Architectural Design Review Board
November 21, 2023 @ 4:00 p.m.
Council Chambers
First Floor, 345 High Street
Hamilton, Ohio 45011

1. 139 Ross Ave – Demo of Rear Addition

To: Architectural Design Review Board
From: Brooke Wells
Subject: New Business - AGENDA ITEM #1
139 Ross Ave – Demolition of Addition to Primary Structure
Tracy Wieland, Applicant
Meeting Date: November 21, 2023
Received Application: October 24, 2023
Impacts: Rossville-Main (Location)

Figure 7: Applicant drawing of proposed demolition project.

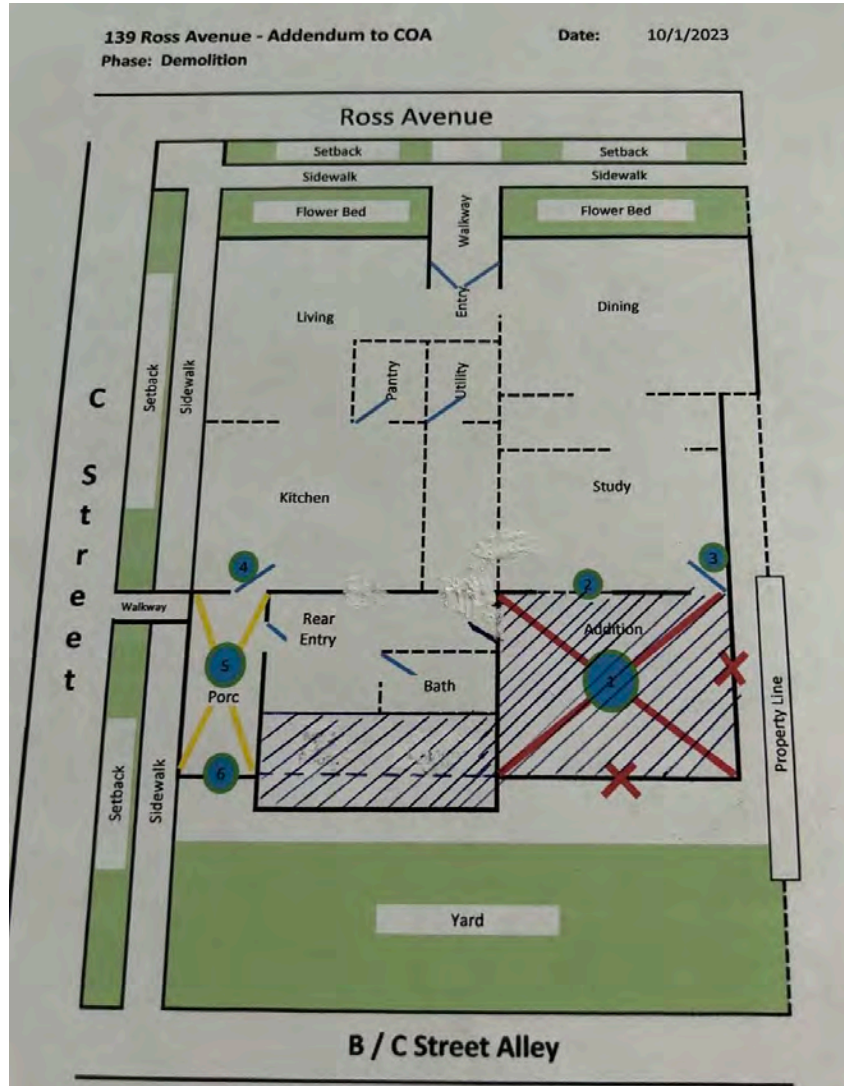
- The additions to 139 Ross Ave are not original, however, they are historic. The build date of the additions date back prior to 1887.
- 139 Ross Ave is very similar in style and construction to the house next door at 129-133 Ross Ave. The property next door at 129-133 Ross Ave has a preservation easement on its front façade.
- 139 Ross Ave is an original Rossville structure, and the original portion of the building (without the additions), is the most important to preserve.

① Elevation - North
SCALE: 1/4" = 1'-0"

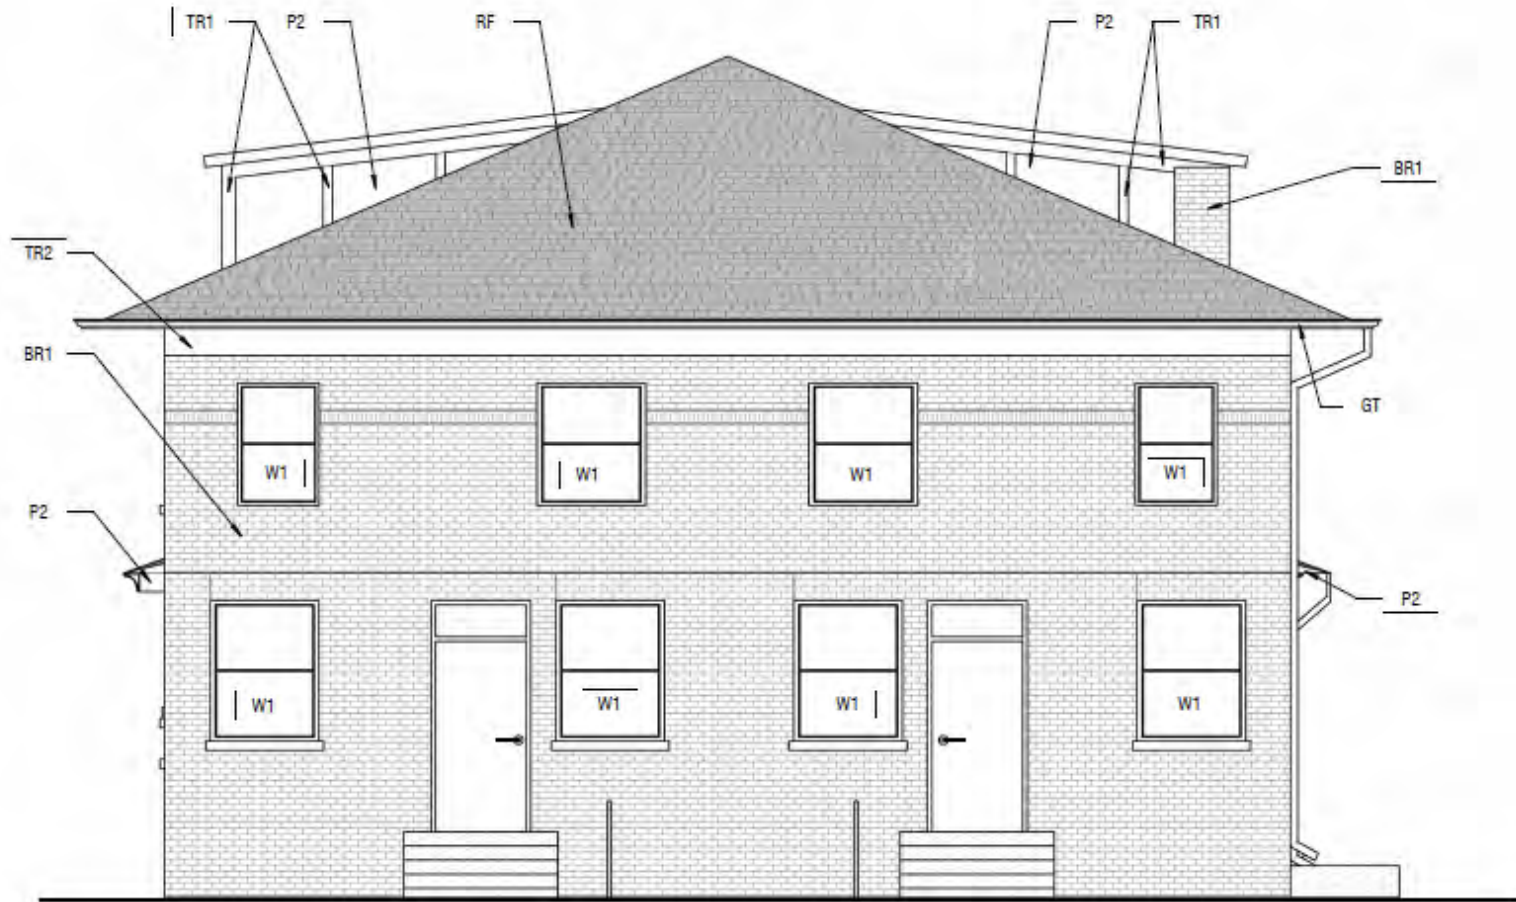
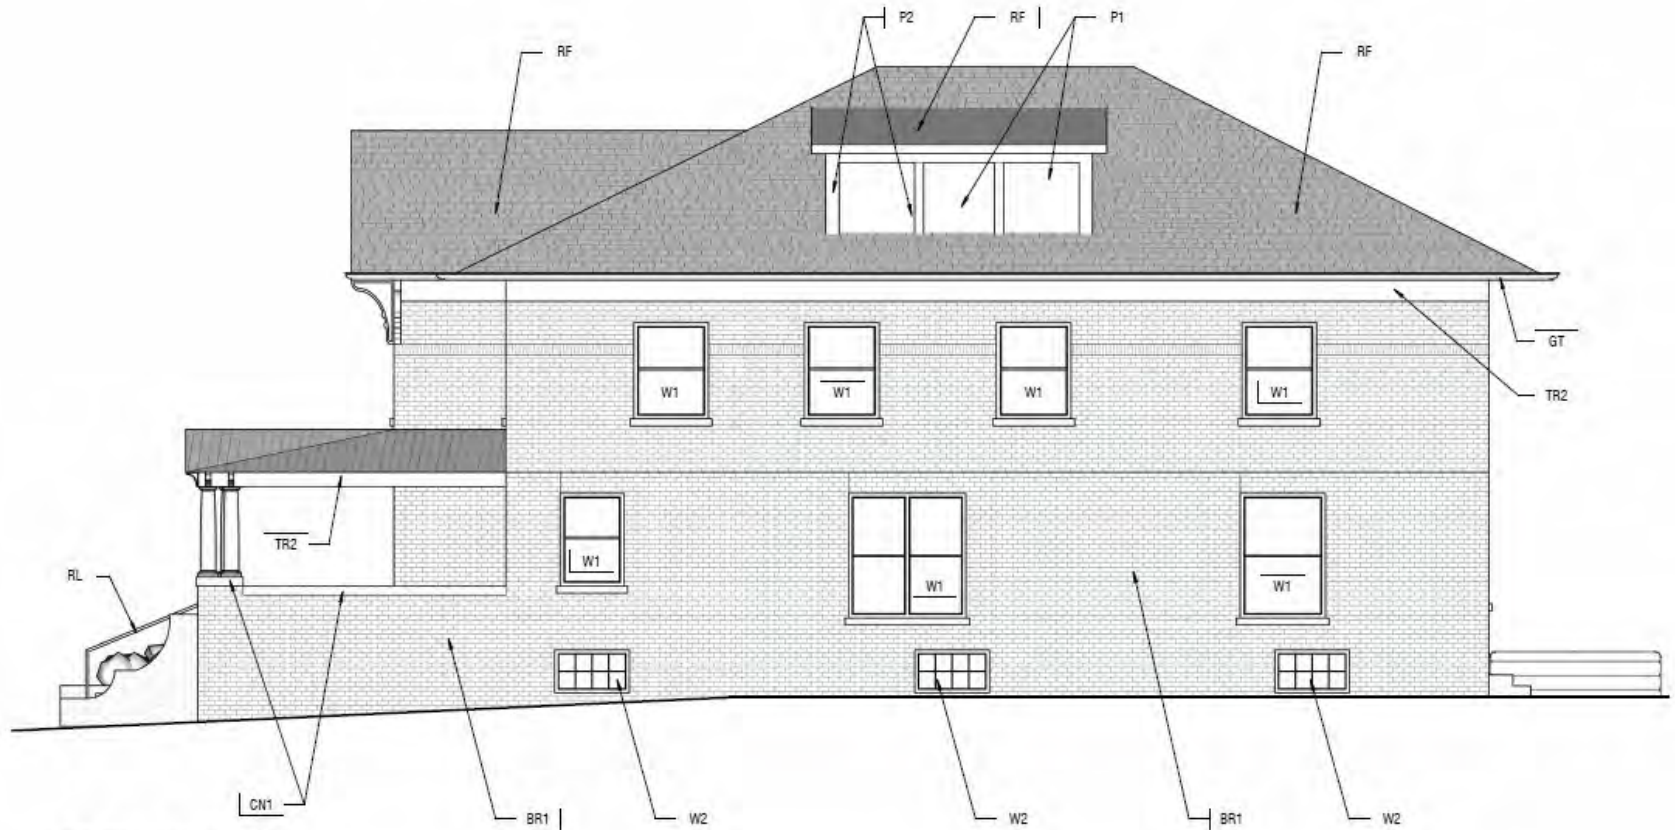
1. The ADRB Policies & Guidelines do not specifically address removal of an existing window for door installation. The proposed doors are wood double doors, with five glass panes, which are similar in transparency to the existing windows.
2. Window replacement is needed in order to remove the existing fixed windows and install operable windows to meet State of Ohio Building Code regulations.
3. The Anderson 400 windows proposed are on the list of Approved Replacement Windows.
4. The transom window will be installed over the 6 over 6, double hung windows, due to size restrictions.
5. Existing lintels and sills will remain with new door and window installation.
6. Applicant will have to come back to the ADRB at a later date for sign approval. No signage is proposed on awning.
